BMW Motorrad Service Information Bulletin

****Recall 06V-164 - Retrofitting Banjo Bolt w/Restrictor****

Subject: Retrofitting banjo bolt with restrictor

Model: K 1200 S (K40), K 1200 R (K43), with Integral ABS
R 1200 GS (K25), R 1200 RT (K28), R 1200 RT (K26) with Integral ABS

Fig. 1: New banjo bolt with restrictor is a hex head design. (K - Model shown)

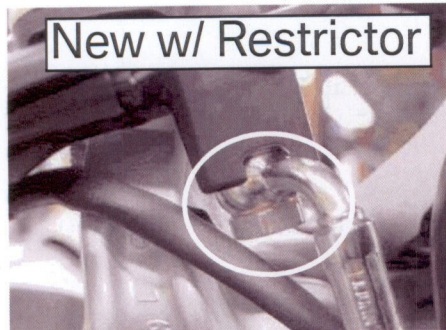
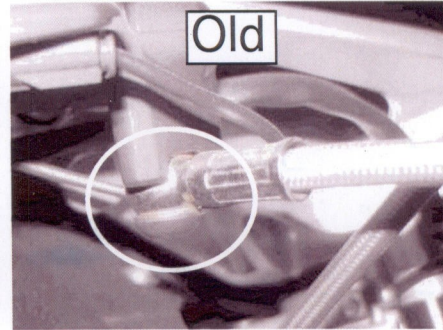
A new banjo bolt with a restrictor is now being installed in the handlebar fitting in series production (see Fig. 1). This banjo bolt incorporates a calibrated orifice plate that limits the increase in pressure and counters the possibility of excessive pressure building up in the Integral ABS system.

Fig. 2: Old banjo bolt is a 'torx'. (K - Model shown)

Motorcycles already produced will have to have the banjo bolt with restrictor retrofitted.

1. Gently pull the brake lever until the blow-by bore in the brake master cylinder is passed.
2. Secure the brake lever in this position.
3. Remove the original banjo bolt and install the new banjo bolt with restrictor (tightening torque 18 Nm). Hold the end of the brake hose up to prevent brake fluid from escaping and air from making its way into the system.
4. Now bleed the system by gently operating the brake lever. Make sure that the motorcycle is propped on its **side stand**; if necessary also move the handlebars from left to right. The advantage of this procedure is that it is not necessary to bleed the modulator.

Fig. 1: New banjo bolt with restrictor is a hex head design. (R - Model shown)

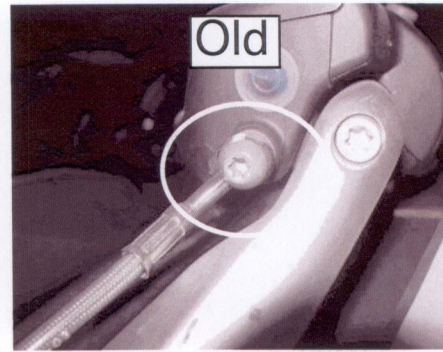
Fig. 2: Old banjo bolt is a 'torx'. (R - Model shown)
